Certificate of Appropriateness

Milwaukee Historic Preservation Commission/841 N Broadway/Milwaukee, WI 53202/phone 414-286-5712

2022 E Lafayette Pl North Point South HD

Current typical circumstances.

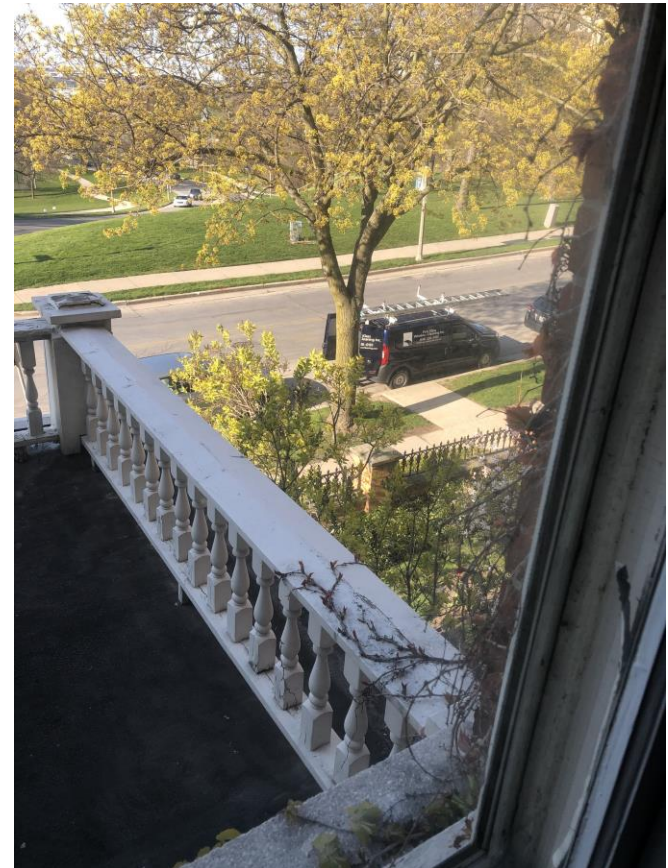
Repair membrane roofs to match existing. As no specific work plan has provided, work shall be conducted according to the best practices established by the Wisconsin Historical Society (see last pages of document).

Replace railings on balcony and roof deck to match existing to the extent practical. Materials shall be replaced in kind with real wood that is to be painted. Top rails at the roof deck shall not be 2x4s and be sloped to shed water. Top rails on the stairs shall comply with UDC requirements for a grippable surface (2x4 top rails on stair railings are prohibited by state building code (SPS 321)).
